INSPECTION REPORT: GREENS CREEK MINE

Date of Inspection: Thursday, July 17, 2014
Date of Report: Tuesday, July 23, 2014
USDA Forest Service Inspector: Curtis Caton

Ranger District: Admiralty National Monument, Juneau Ranger District
Weather Conditions: partly cloudy. Temperatures in the mid 50's (°F).

Photo 14. Zinc Creek Bridge access road.

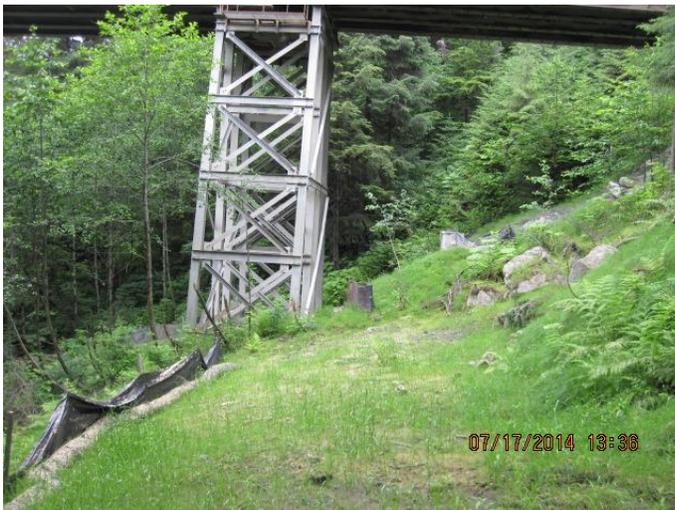
The B road crosses Zinc Creek at approximately mile marker 3.0. BMPs for stormwater outfall 005.2 (west side Zinc Creek Bridge) comply with Appendix 5 of the General Plan of Operations. Hydroseeding, silt fencing, and sediment barriers have minimized erosion on the Zinc Creek Bridge access road (Photos 14-16).
